DOCUMENT CHANGE NOTICE (DCN)

DOCUMENT No. (DOC-REV-GP. ID)	TITLE	NEW REV.
D990094-A	Cavity Beam Dump Assembly	B
D990140-A	Cavity Beam Dump Housing Plate	B
D990141-A	Cavity Beam Dump Housing Assembly	B
D990222-n/a	Cavity Beam Dump Housing Tube, BSC8, 2KBSAR3	A
D990223-n/a	Cavity Beam Dump Housing Tube, BSC8, 2KFMYY	A
D990224-n/a	Cavity Beam Dump Housing Tube, BSC8, 2KFMYY	A
D990225-n/a	Cavity Beam Dump Housing Tube, BSC8, 4KITMYHR3, 4KITMYHR4	A

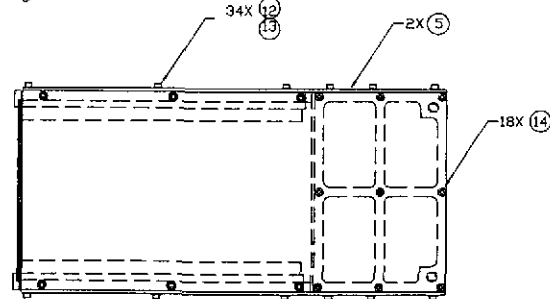
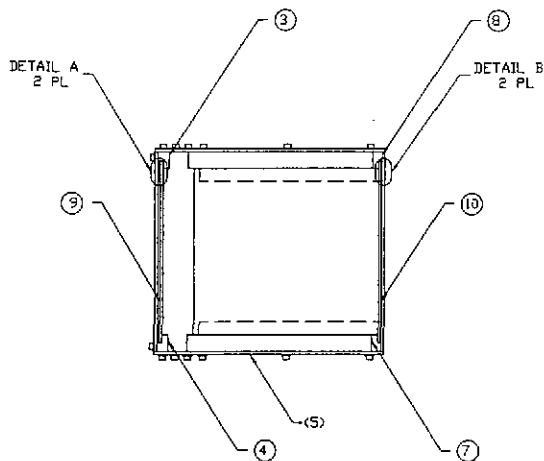
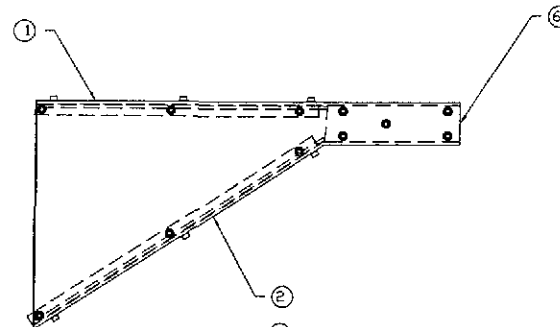
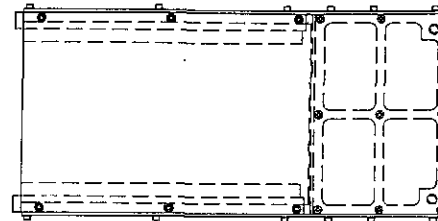
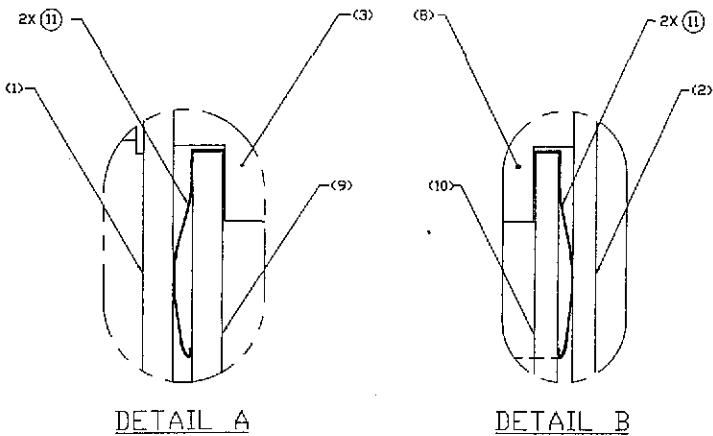
D990140: Added ventilation lands and shortened part length to 8.09" eliminating two mounting holes.

D990141: Revised to show added hardware and changes in assembly parts. Changed entry in Next Assembly block from D990145 to D990230.

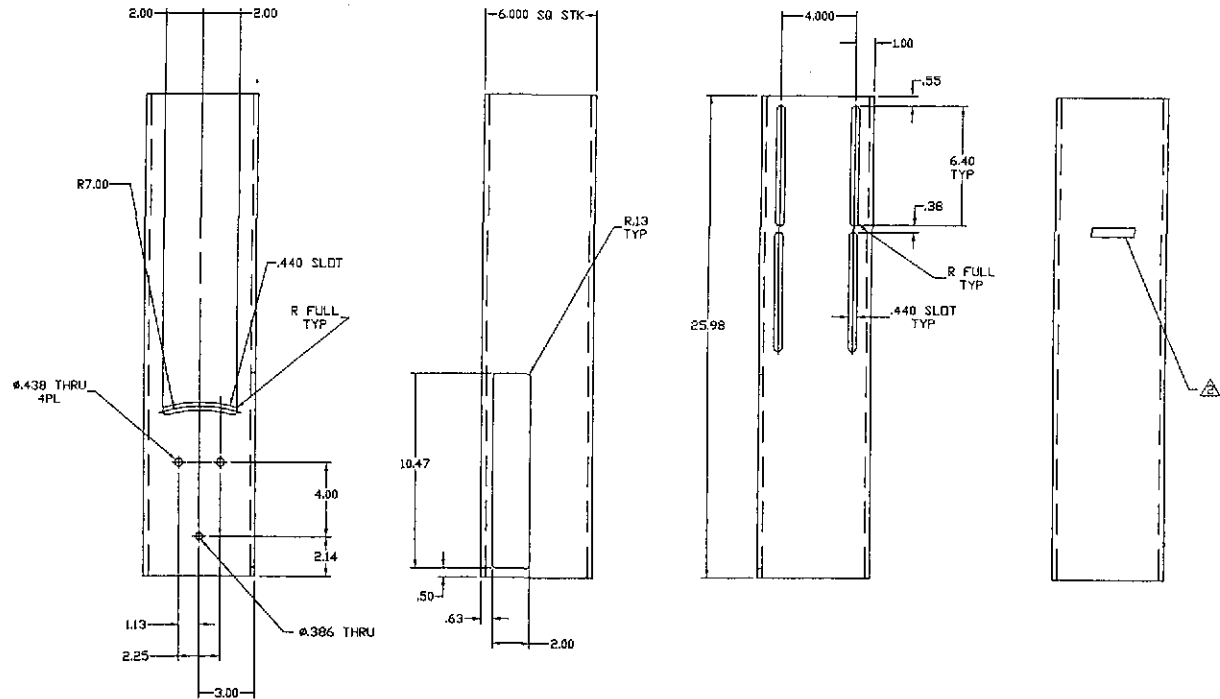
D990094: Changed entry in Next Assembly block from D990145 to D990230.
